RE: Wichita Biomedical Campus - Phase 1
JE Dunn Project No. 23044000

PR 001 - Drawing Modifications

PROPOSAL REQUEST 001

Wichita Biomedical Campus: Bid & Permit Package #1
08.15.24

C200

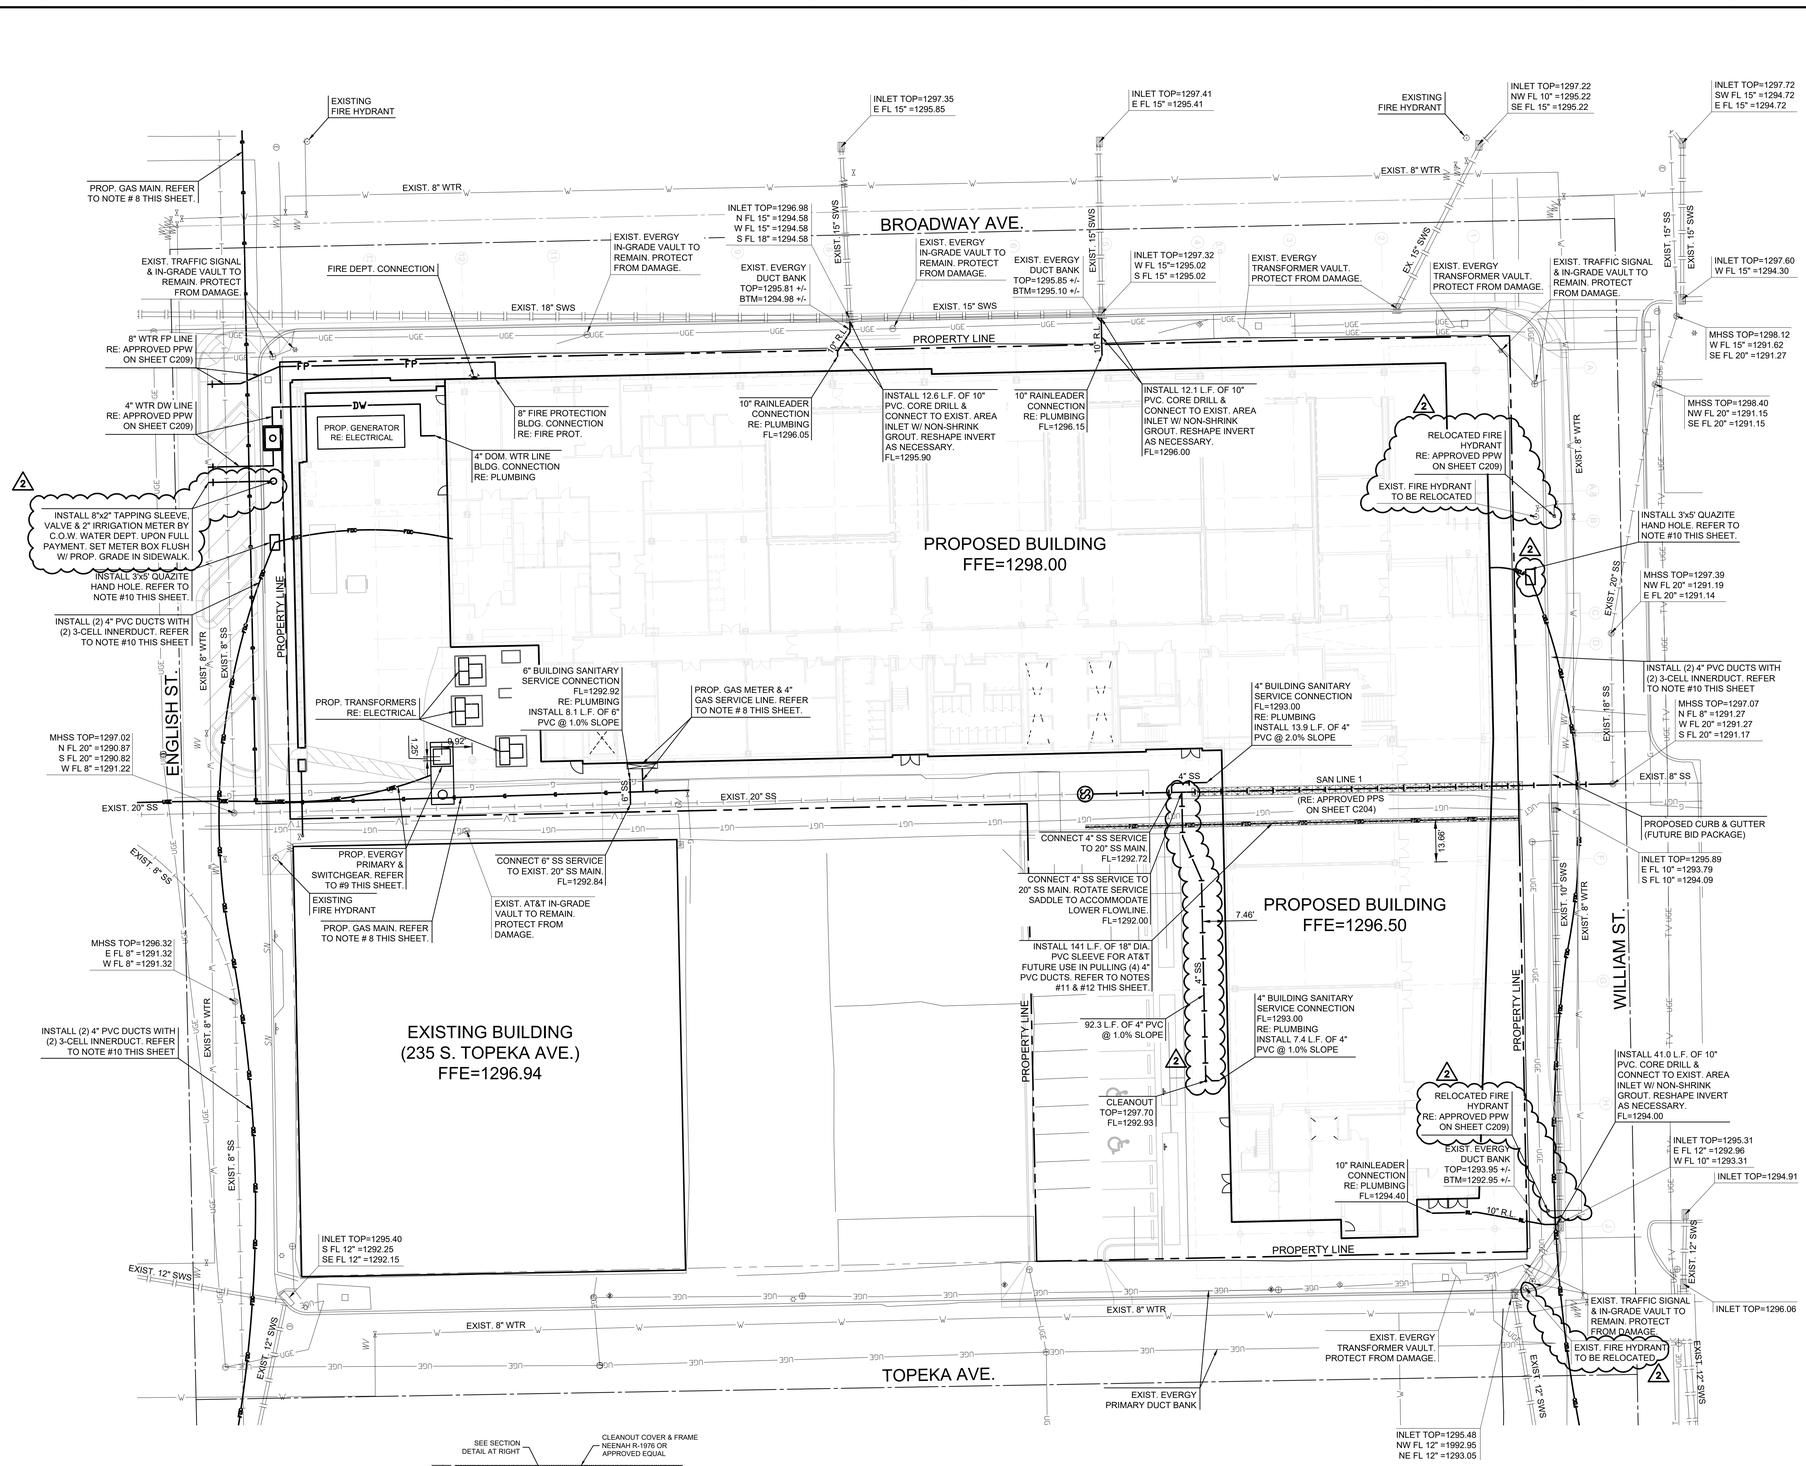
- **ADD** 2" irrigation tap and meter.
- **ADJUST** sanitary sewer service line to miss a proposed landscape curb.
- **RELOCATE** two relocated fire hydrants referenced along William St.
- **ADJUST** fiber optic hand hole location.

C204

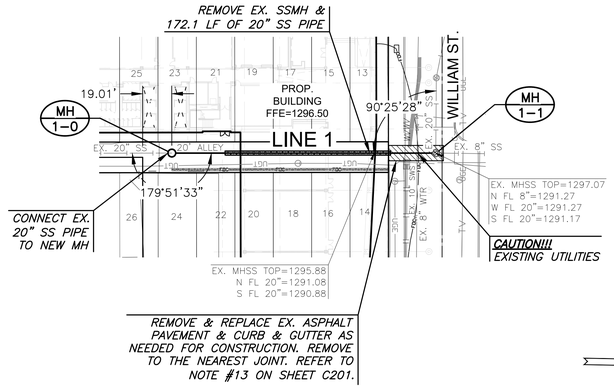
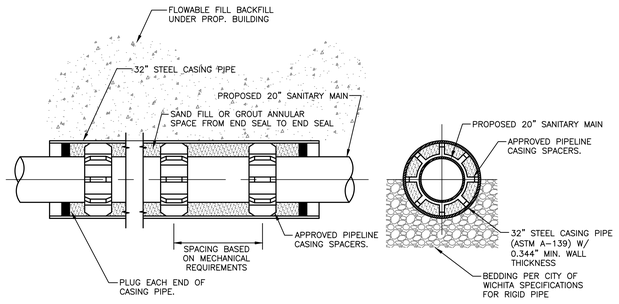
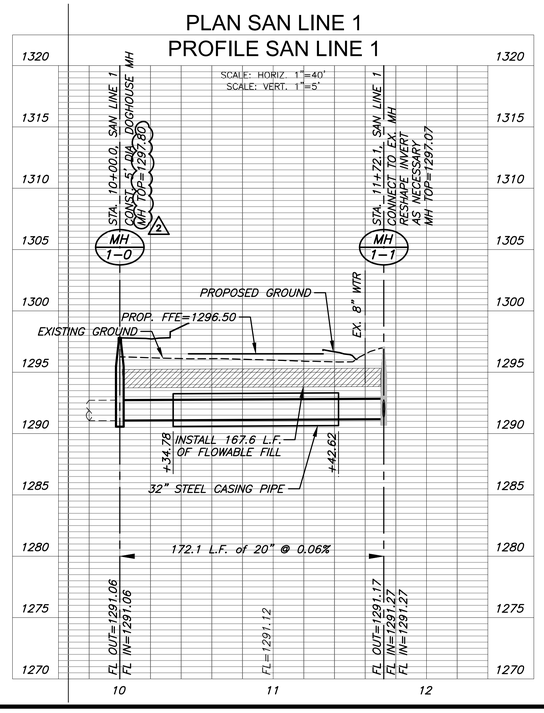
- **ADJUST** manhole elevation to reflect updated proposed grading.

C209

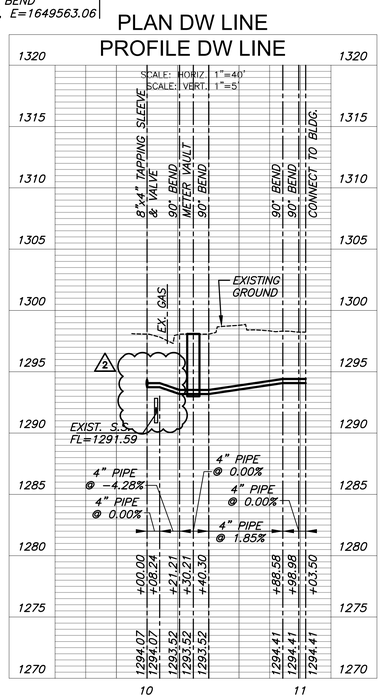
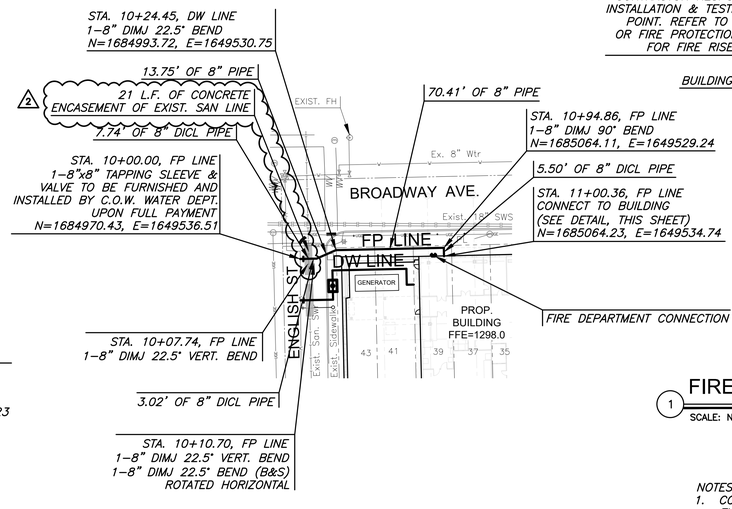
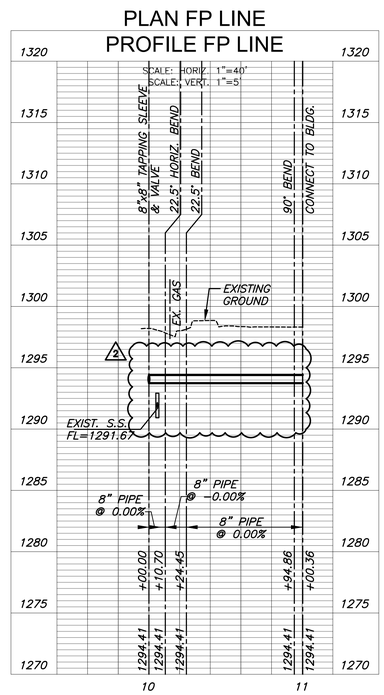
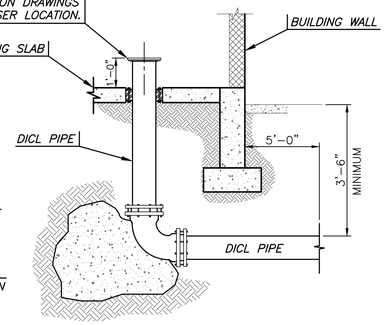
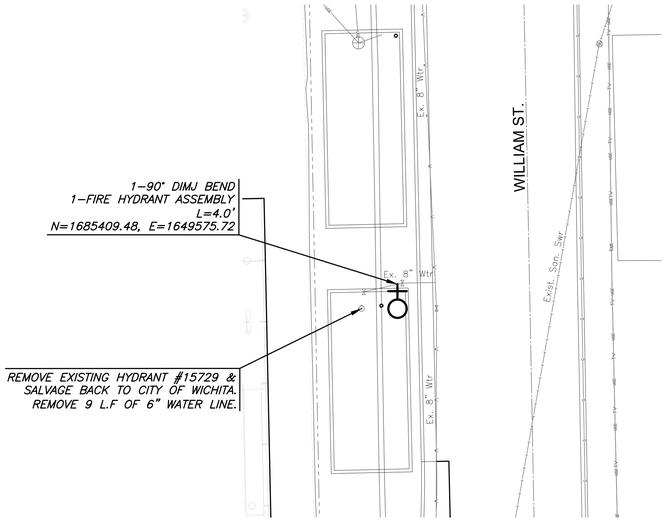
- **ADD** encasement of the existing 8" sanitary sewer at both water line crossing locations (42ft – 21ft at each crossing) per new City of Wichita comments.

C209A

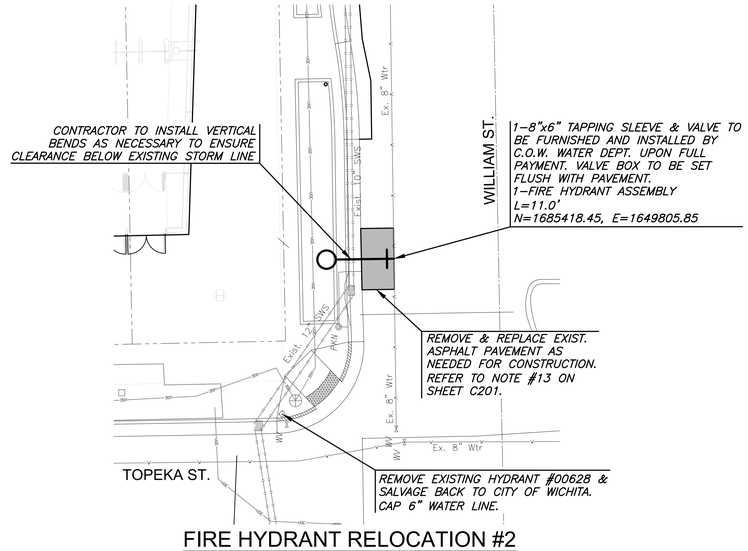
- **ADD** new sheet. This sheet includes the existing fire hydrant relocations along William St. within the new landscape beds.
